Objection to the proposed Seniors Living Development at 19-23 Rosalind Street, Cammeray on the NSW planning portal, reference SD-96505456

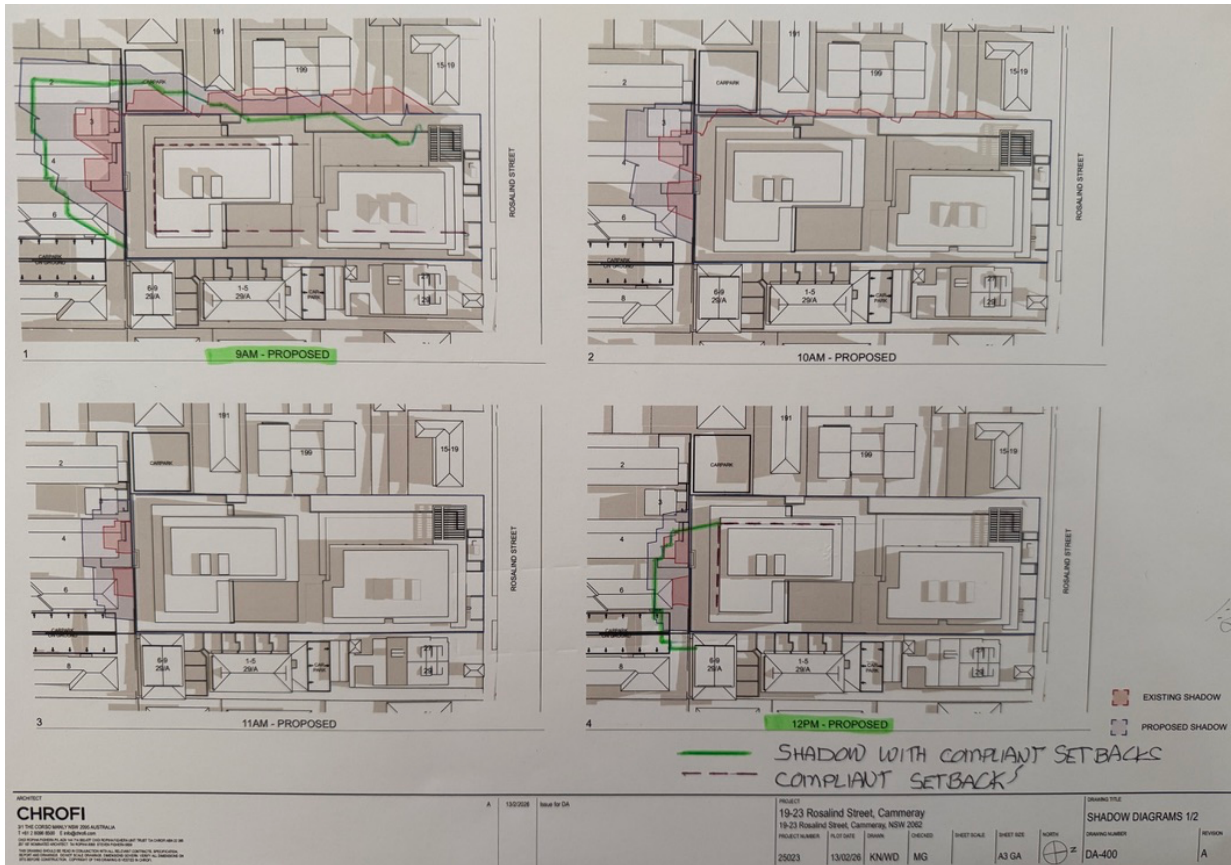
I've marked up the solar shadow drawings DA 400* and DA 401* prepared by the proponent, forming part of the application, to show the “proposed shadowing” if the building setbacks to the towers were based on compliance and it is clearly demonstrated that the shadowing impact on all neighbours is significantly reduced even with the benefit of the increased building height sought by the proponent.

Refer to the significant reduction in solar shadowing, marked up in green for 9am and noon, should the towers have compliant side and rear setbacks
